BioPark Planning Appeal Proof of Evidence Welwyn Garden City Society

Architecture

Appendices

View from South West looking North East.

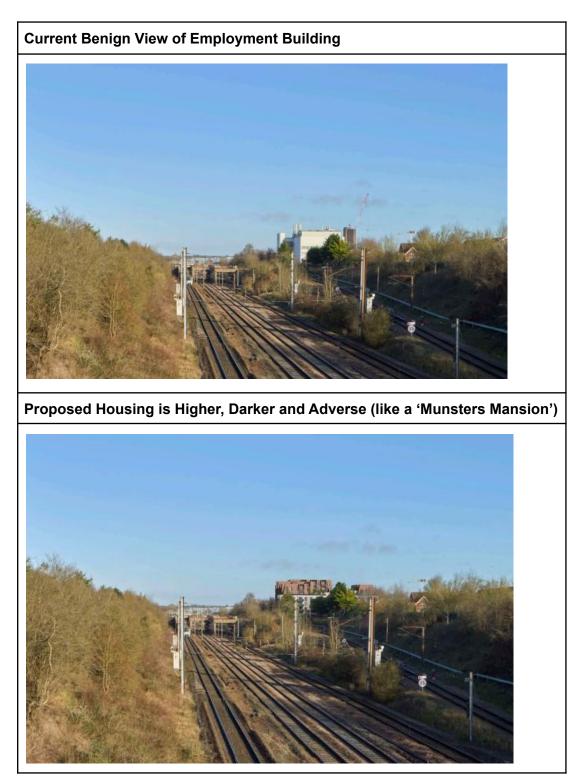
A: 3-D Model Demonstrating That The Proposal Is Totally out of Scale to Adjacent Site

The Proposal is in grey on the right.

The neighbouring Mirage housing site is shown in white on the right and is dwarfed by the Proposal.
